RE: 915 Silver Ave. SW
Permanent C.O. - Accepted
Engineer's Certification Date: 07/07/20
Engineer's Stamp Date: 07/25/19
Hydrology File: K14D118

DRAINAGE AND TRANSPORTATION INFORMATION SHEET (REV 11/2018)

Re: Hydrology File #K14D118, 913 and 915 Silver Ave. SW

Site Landscape

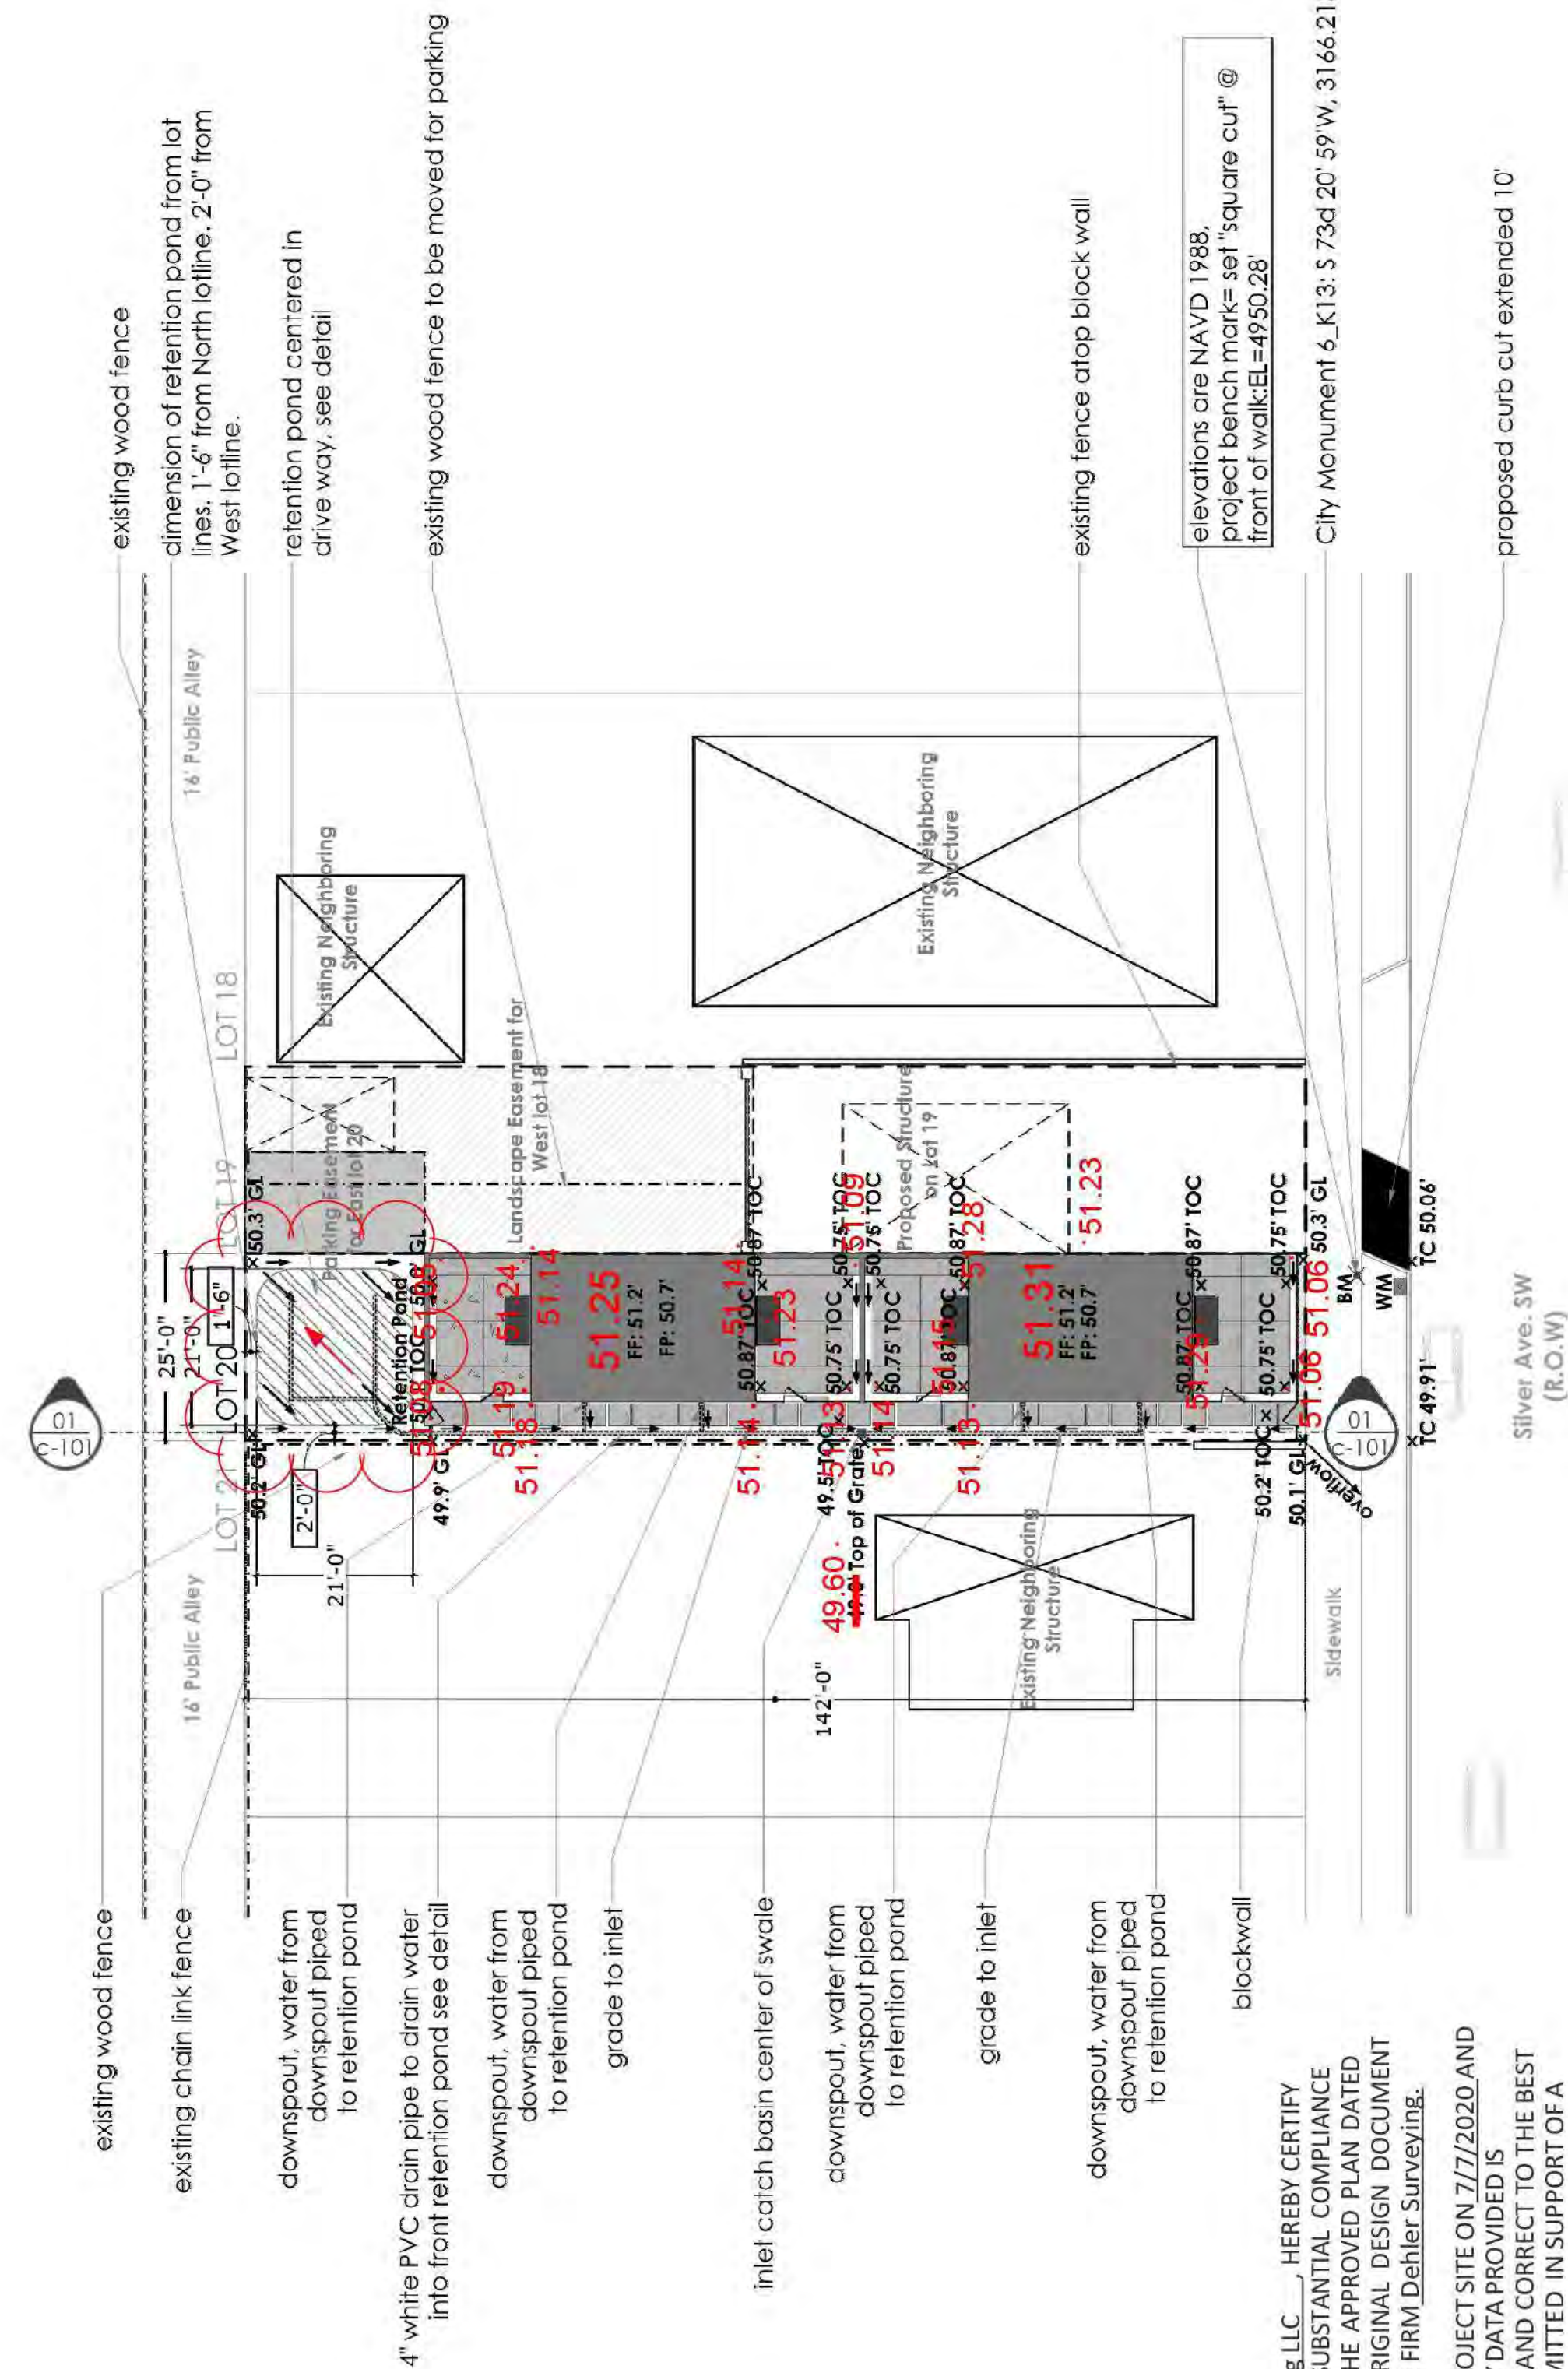
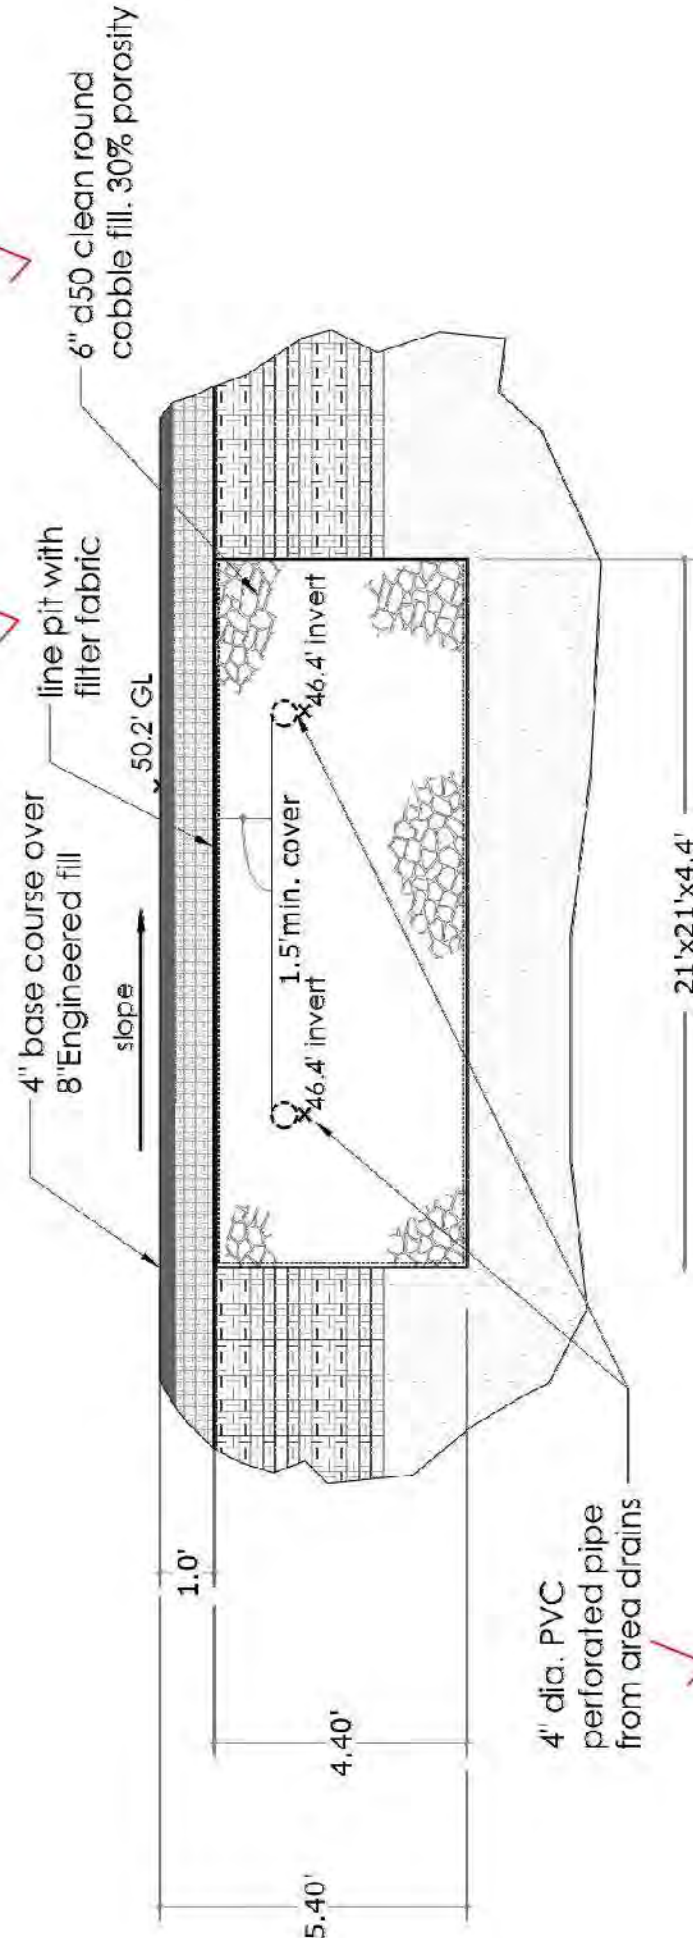
NOTED DEVIATIONS FROM THIS PLAN ARE :

- 1) PATIOS AND SIDEWALKS WERE RAISED TO FACILITATE WHEELCHAIR ACCESS TO BUILDINGS.
- 2) PARKING AREA WAS GRADED TO TIE TO SIDEWALK AND NOW DRAINS OFFSITE.

Site Landscape

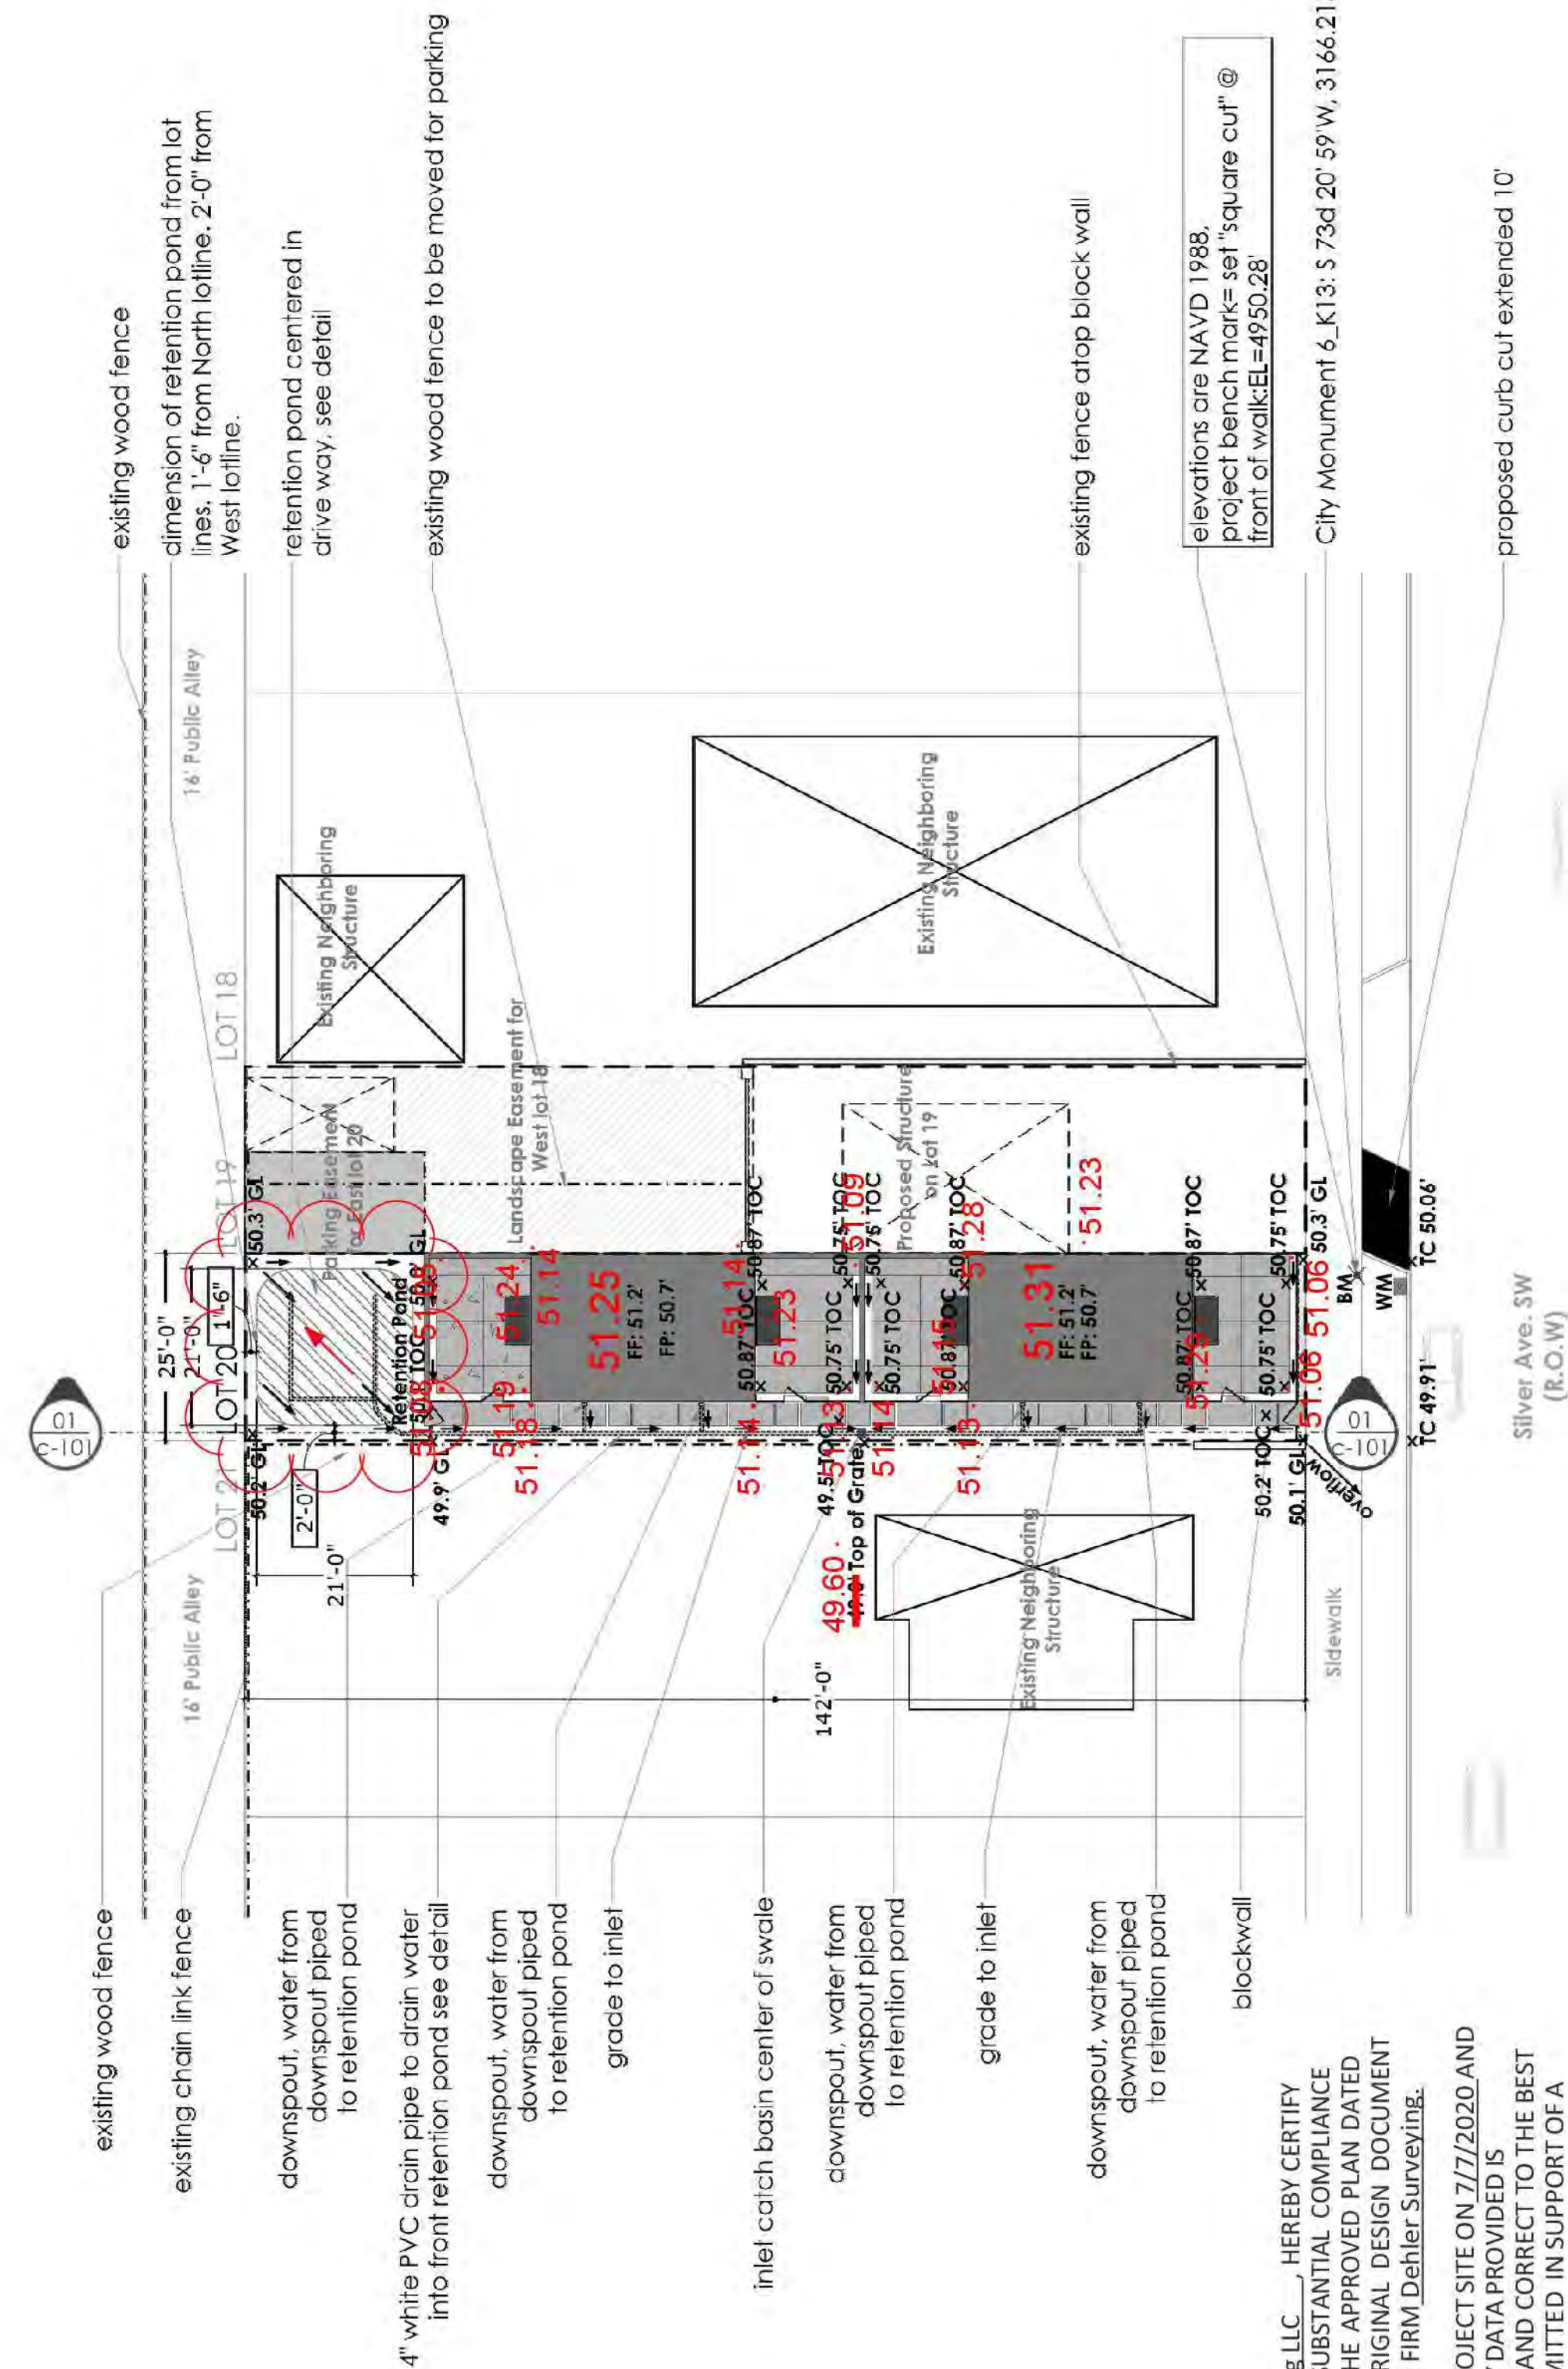
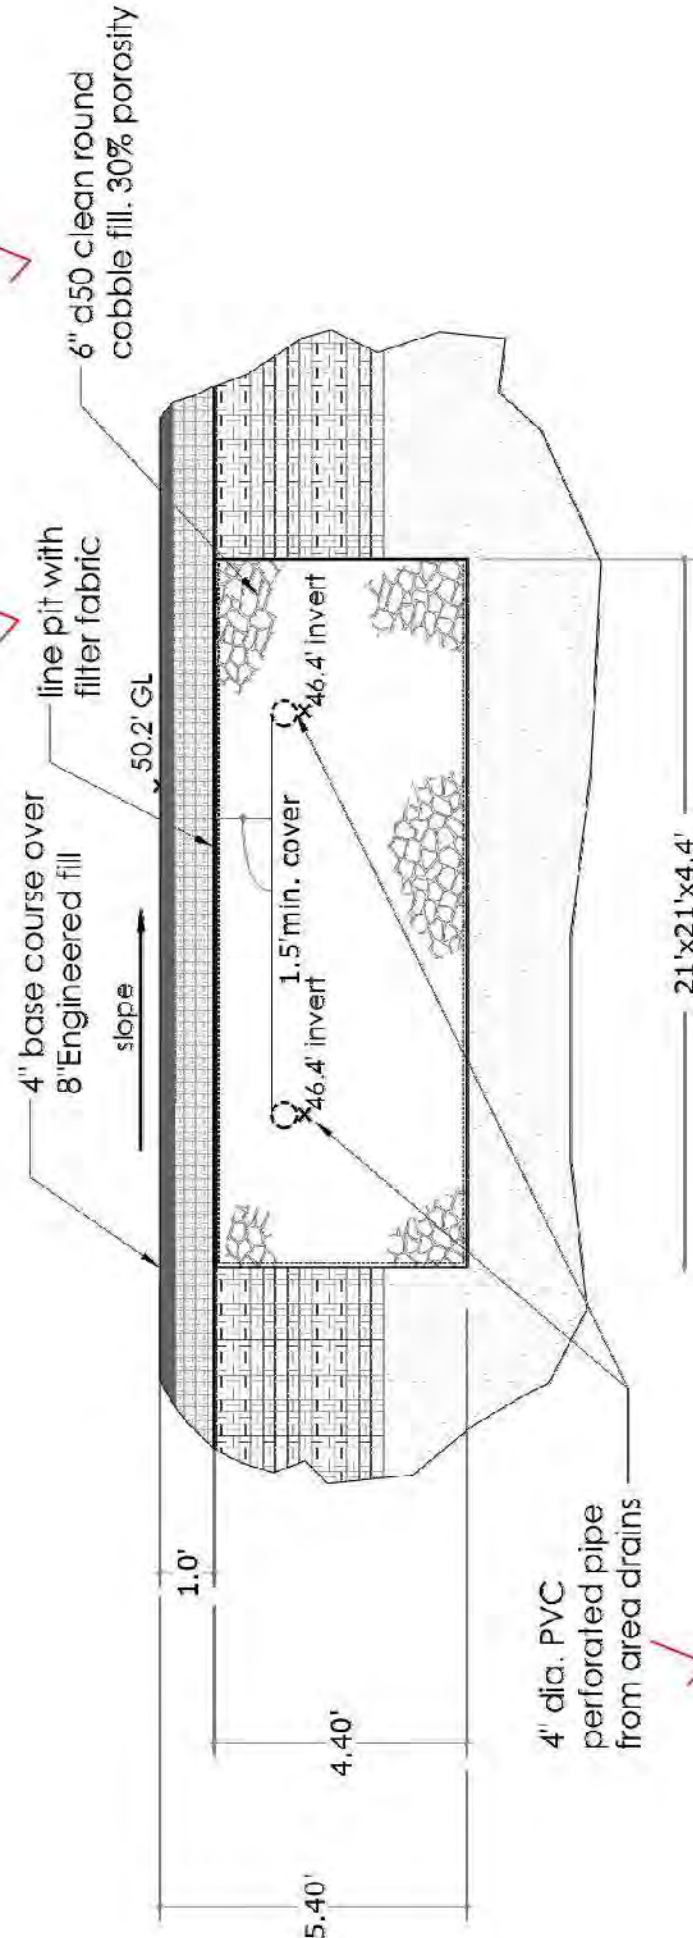
NOTED DEVIATIONS FROM THIS PLAN ARE :

- 1) PATIOS AND SIDEWALKS WERE RAISED TO FACILITATE WHEELCHAIR ACCESS TO BUILDINGS.
- 2) PARKING AREA WAS GRADED TO TIE TO SIDEWALK AND NOW DRAINS OFFSITE.
